SECTION 4.55(1A) MODIFICATION APPLICATION – SSD 6966 BUILDING R5, ONE SYDNEY HARBOUR, BARANGAROO SOUTH

This modification application has been prepared by Ethos Urban on behalf of Lendlease (Millers Point) Pty Ltd (Lendlease), pursuant to section 4.55(1A) of the *Environmental Planning and Assessment Act 1979* (EP&A Act) to modify Development Consent SSD 6966 relating to Residential Building R5 at Barangaroo South (the site).

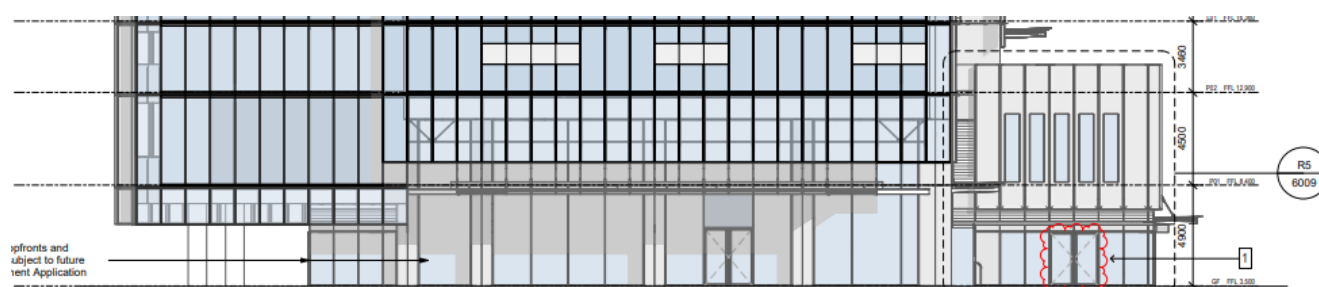
The proposed modifications include the installation of retail shopfronts. Under the current consent and within the existing stamped plans, the approval of these shopfronts is subject to a future, separate individual design process and their own Development Application (DA). On a further design review, it is considered that providing for the shopfronts as part of an integrated approach will provide a better response to the broader architecture of the building and will result in a more cohesive design outcome together with the other shopfronts approved under Building R4A (SSD 6964) and SSD 6965 (as amended by SSD8892218).

Figure 1 Façade changes on the northeast elevation

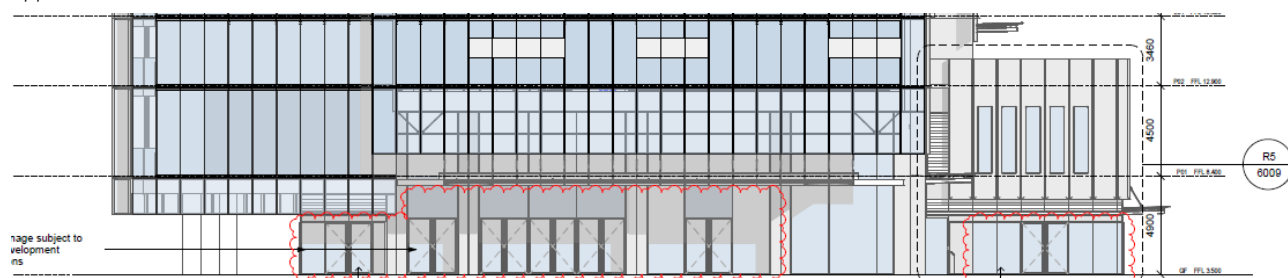
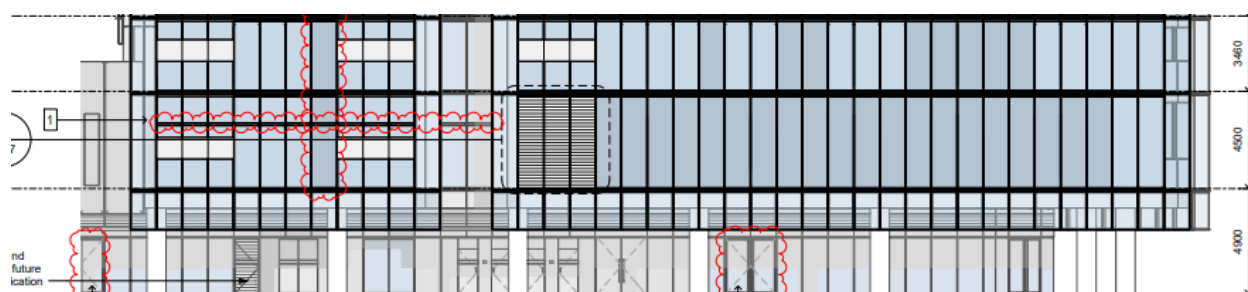
It is proposed to reconfigure the façade at the ground level elevation to facilitate the following:

- Additional retail shopfronts/entrances around the ground floor of the building.
- Additional door for fire booster cabinet fronting Hickson Road.
